Rampion 2 Wind Farm

8.54 Applicant's Response to Examining Authority's Written Questions – Fish and Shellfish Appendix H: Appendix H Noise Thresholds for Black Seabream (clean)

Date: July 2024
Revision A

Application Reference: 8.54.1
Pursuant to: The Infrastructure Planning (Examination Procedure) Rules 2010, Rule 8(1)(c)
Ecodoc Reference: 005265836-01

Figure 2-1: Piling exclusion zone for the piling of monopiles, with 20dB reduction (Unwtd 135dB SELs)

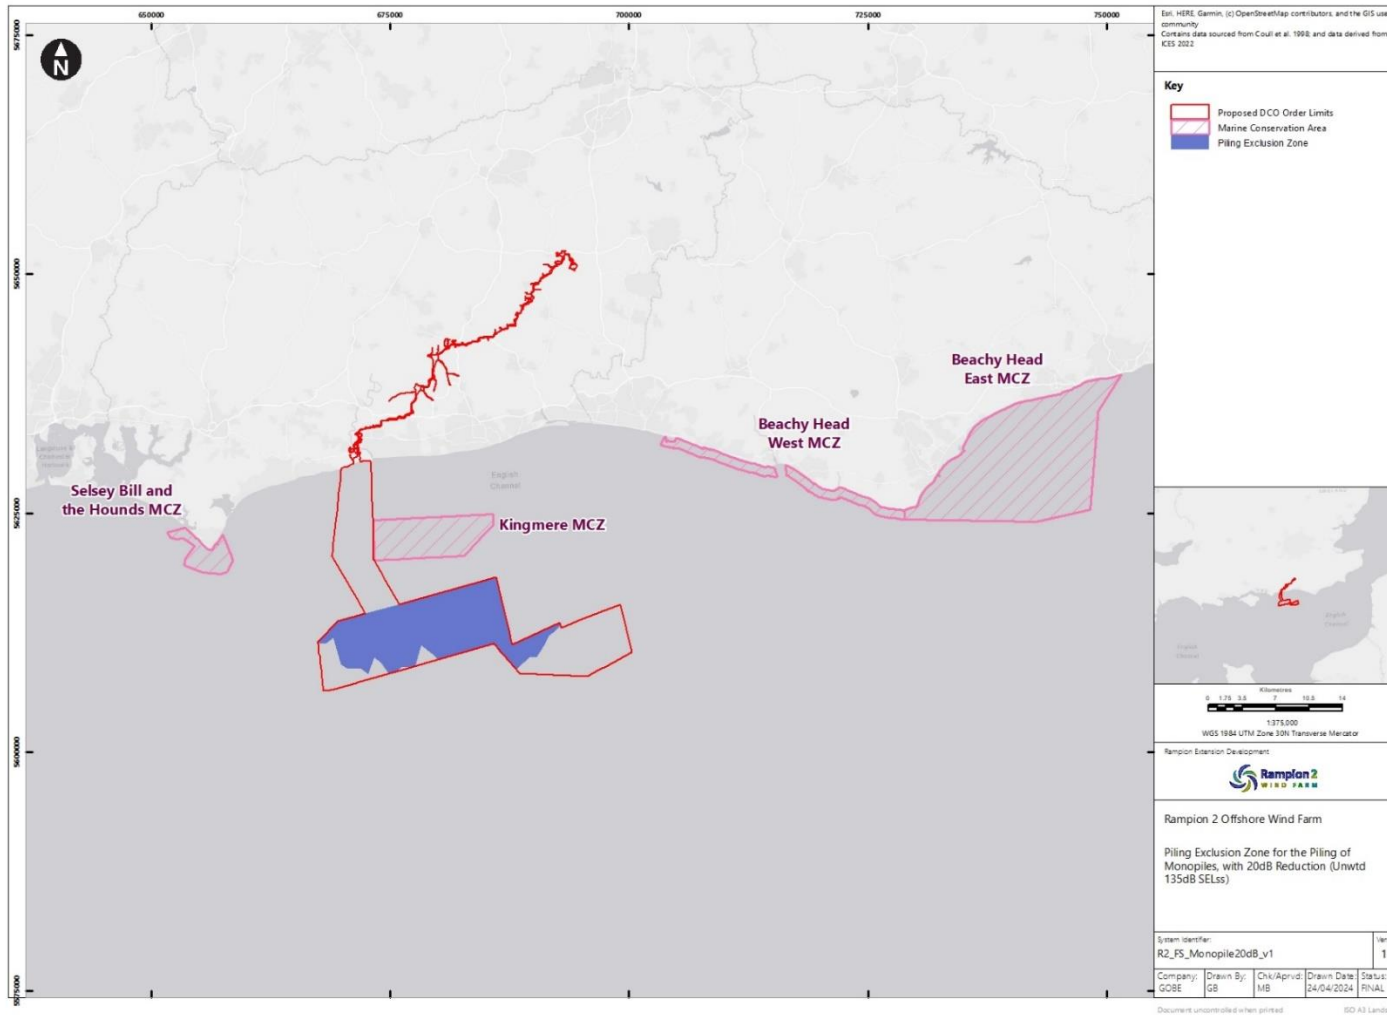
"The Applicant also states that the revised modelling presented here indicates the proposed zoning approach for piling during July in the western part of the array is also not feasible under either monopile or multileg piling scenarios. It should be noted that the MMO have not supported this zoning plan based on modelling of the inappropriate 141 dB threshold and have repeatedly asked the Applicant to demonstrate the feasibility of this approach when modelled using the more appropriate 135 dB threshold.

- 1.2.2 The areas available for piling multileg and monopile foundations on the basis of achieving a 135 dB SELss threshold are clearly shown in figures within this document, which have not required updating from the original version submitted a Deadline 3 **[REP-051]**, specifically:
- **Figure 2-1: Piling exclusion zone for the piling of monopiles, with 20dB reduction (Unwtd 135dB SELss); and**

- 2.2.8 It is clear from Figure 2-1 to Figure 2-4, to achieve a level of received noise no more than 135dB SELss at the Kingmere MCZ site, the piling of multileg or monopile foundations with the implementation of DBBC + PULSE or MNRU hammer mitigation (20dB mitigation) results in significant piling exclusion zones being required across the western portion of the array area.

- 2.2.9 As evident in Figure 2-1 and Figure 2-2, the piling of monopile foundations with 20dB mitigation results in a substantially larger piling exclusion area in the northern section of the offshore array area for the 135dB SELss threshold in comparison to 141dB SELss. Due to the reduced hammer energy when piling multileg foundations, compared to that of monopiles, the impact ranges are smaller under the same mitigation scenarios, therefore the defined piling exclusion zones are also smaller (Figure 2-3 and Figure 2-4), though again the use of the 135dB SELss behavioural threshold (which is not applicable for a noisy environment such as the English Channel) to inform the zoning exercise has led to the definition of significantly larger piling exclusion zones than those defined using the 141dB SELss threshold. The Applicant highlights that the exclusion zones resulting from the 135dB SELss target noise level, which encompass the majority of the western array area, will have significant implications on the mitigation measures proposed in the **In Principle Sensitive Features Mitigation Plan [REP1-012]** (updated at Deadline 3), and consequently the, piling programme. Such implications are detailed in Section 2.4 below.

The Applicant wishes to clarify that the text on page 634 of **8.54 Applicant's Responses to Examining Authority's First Written Questions (ExQ1) [REP3-051]** was submitted in an incorrect form. The Applicant highlights that, whilst the implementation of zoning to accommodate the reduced (stricter) noise threshold of 135 dB SELss would be extremely challenging in combination with other environmental and construction factors, it remains feasible to undertake piling activities within parts of the Offshore Array Area with the proposed mitigation in place for both multileg foundations using pin-piles and monopile foundation structures.

- 2.3.4 The proposed mitigations from March through to June, as detailed in the **In Principle Sensitive Features Mitigation Plan [APP-239]** can be applied if they are defined using the 135dB SELss threshold, with a 20dB noise abatement. However, it should be noted, that whilst the piling exclusion area resulting from the implementation of the 135dB SELss threshold (as opposed to the proposed 141dB

Figure 2-3: Piling exclusion zone for the piling of multileg foundations, with 20dB reduction (Unwtd 135dB SELss)

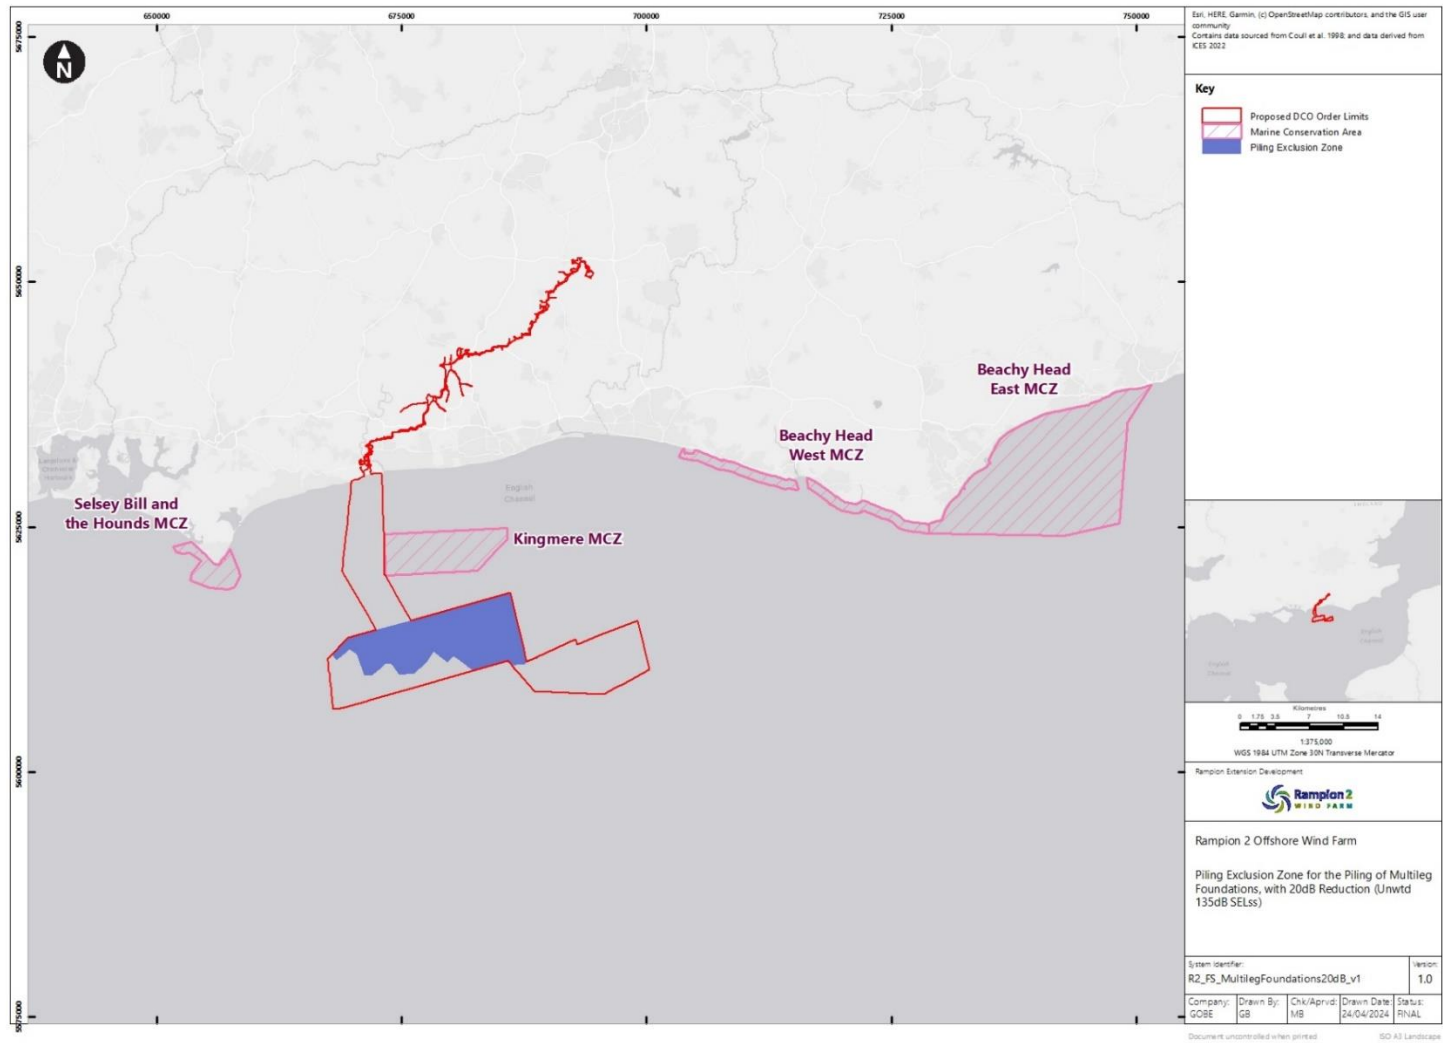
- **Figure 2-3: Piling exclusion zone for the piling of multileg foundations, with 20dB reduction (Unwtd 135dB SELss).**

- 2.3.6 During July, the exclusion zones as detailed in the **In Principle Sensitive Features Mitigation Plan [REP1-012]** (updated at Deadline 3) can be applied if they are defined using the 135dB SELss threshold, with a 20dB noise abatement. However, it should be noted, that whilst the piling exclusion area resulting from the implementation of the 135dB SELss threshold (as opposed to the proposed 141dB threshold) increases the exclusion zone across a relatively small part of the eastern array area (as evident in Figure 2-2) this still has significant issues on the piling programme for the project. Such implications are detailed in **Section 2.4** of this clarification note.
